ADDENDUM NO. 01, dated June 21, 2023.

RE: BID 652, VENTURA COLLEGE CHILD DEVELOPMENT CENTER MODULAR – CLASSROOM & TWO SHADE STRUCTURES
AT
VENTURA COLLEGE
located at 4665 Telegraph Road, Ventura, CA 93003

- A. CHANGES TO BIDDING DOCUMENTS: None.
- B. CHANGES TO SPECIFICATIONS: None.
- C. CHANGES TO DRAWINGS: G0.00, A0.22, FP0.01 ADDITIONAL SHEETS: C3.0, C4.0

**FIRE WATER &
HYDRANT PLAN**

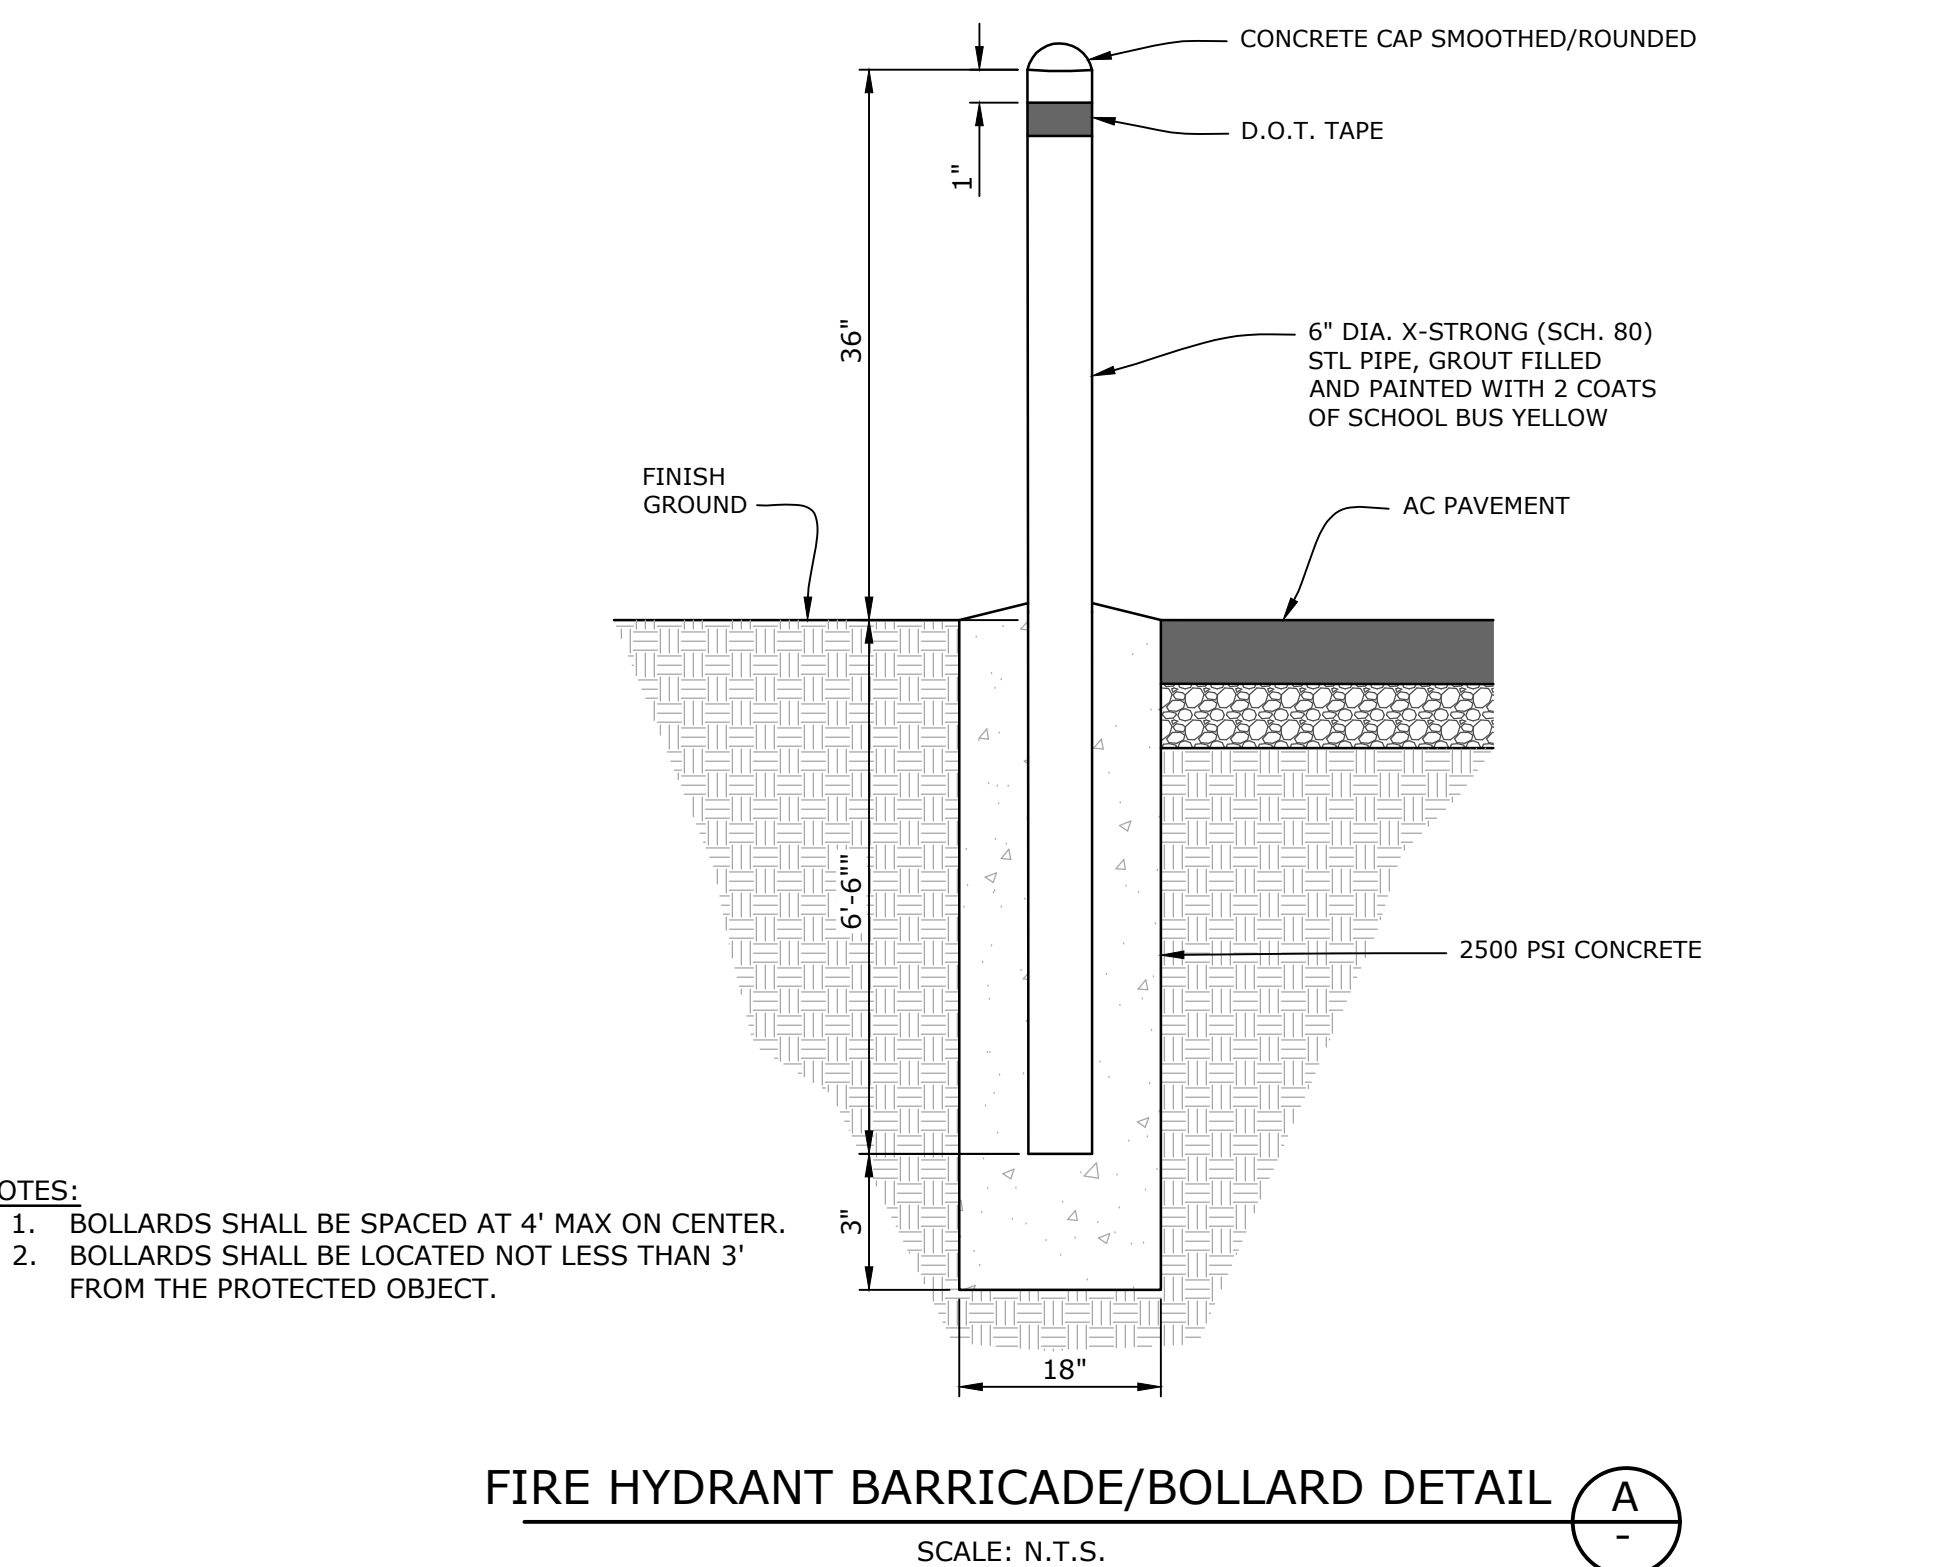
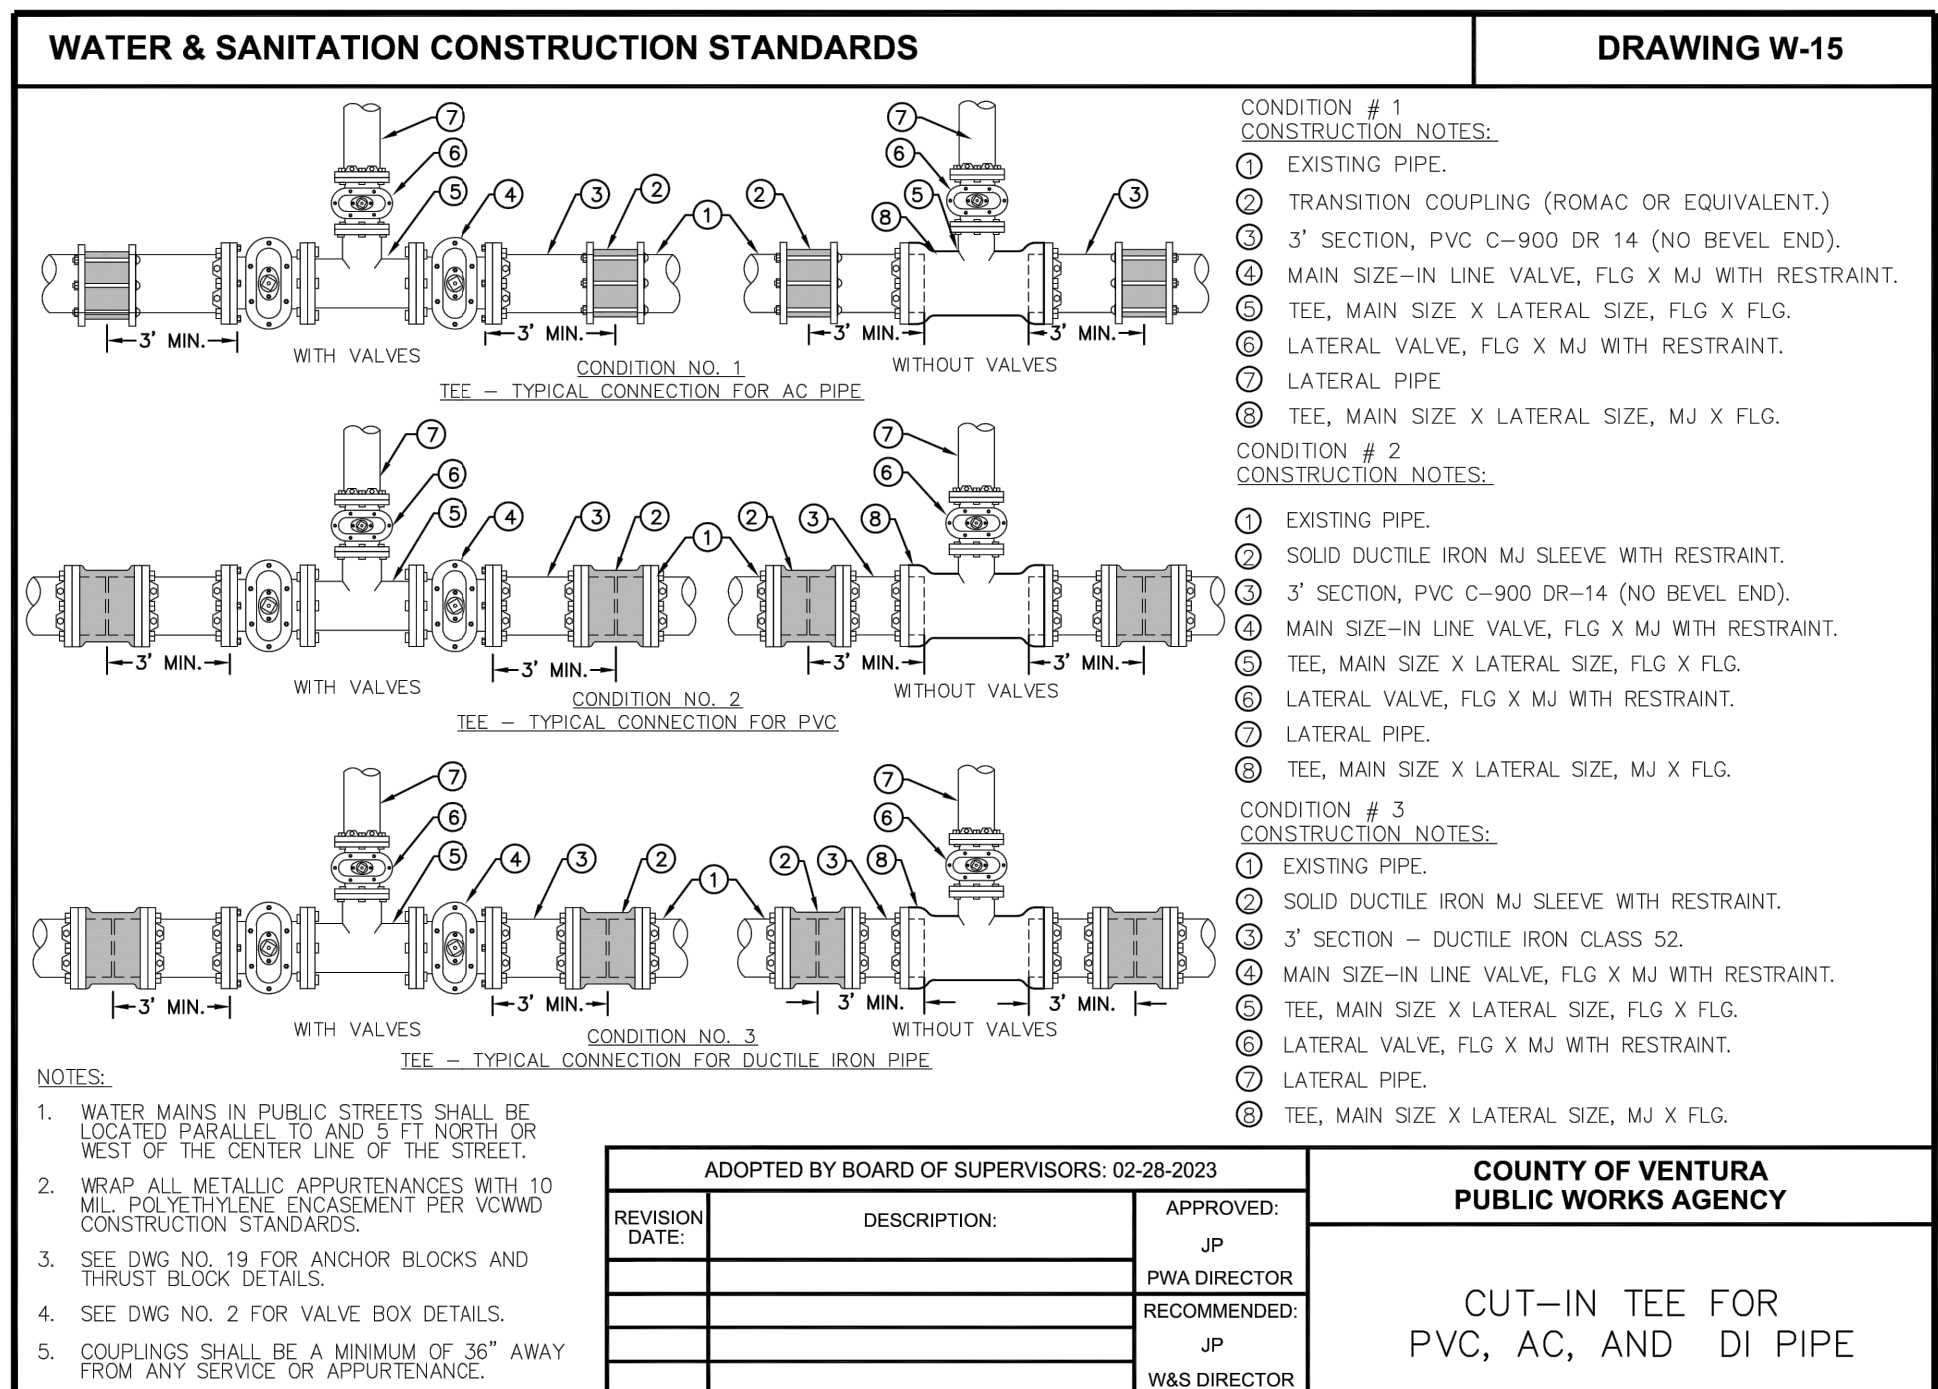
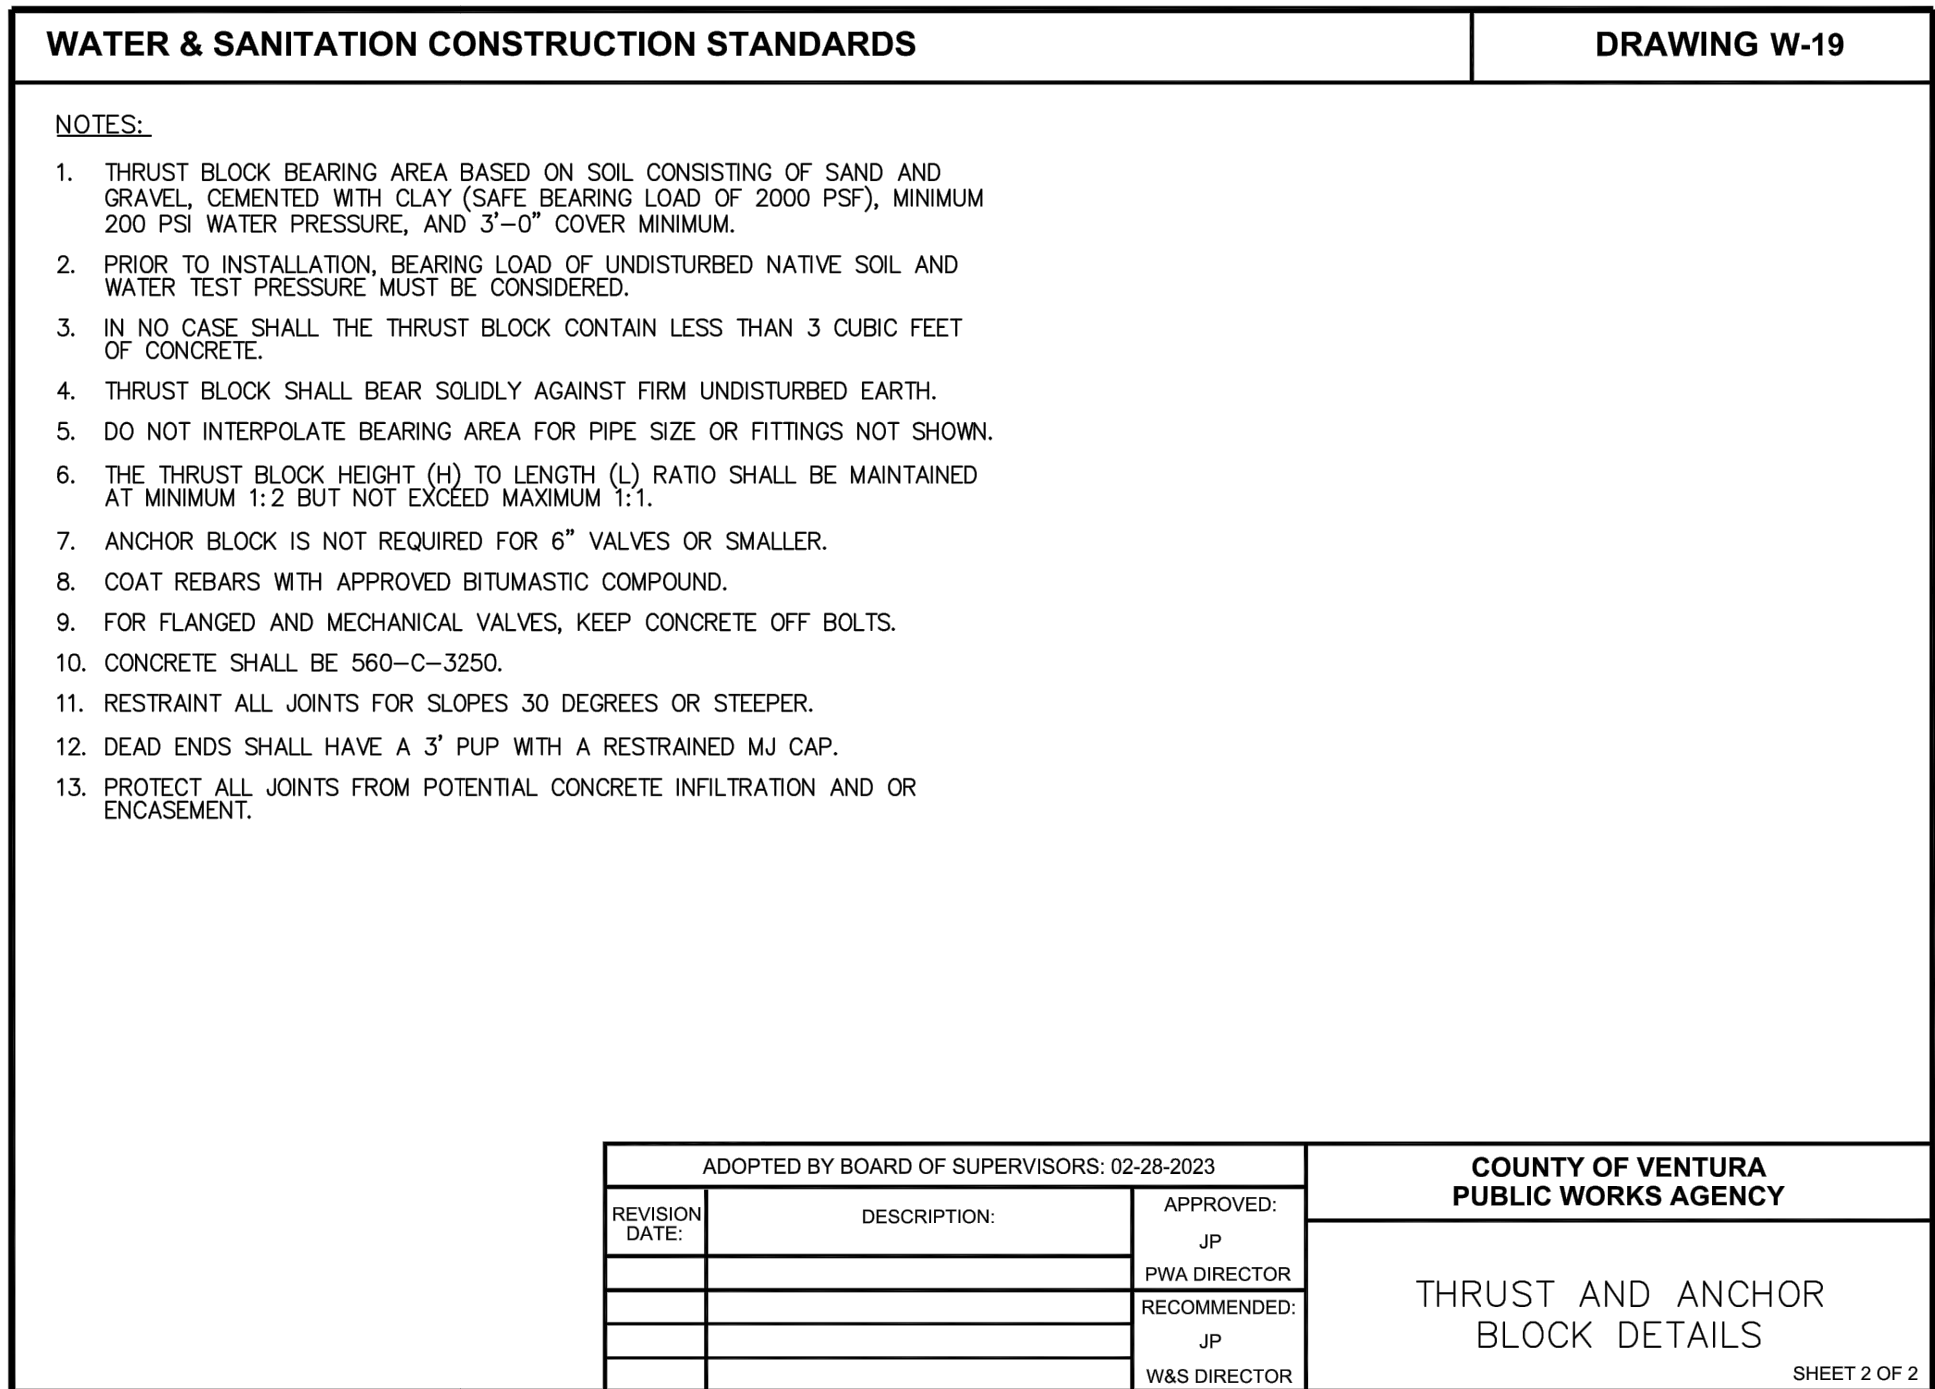
Answer: No
23. Who is going to install the fire hydrant?
Answer: The General Contractor
24. Who is going to install the TMP ramp for the new modular building?
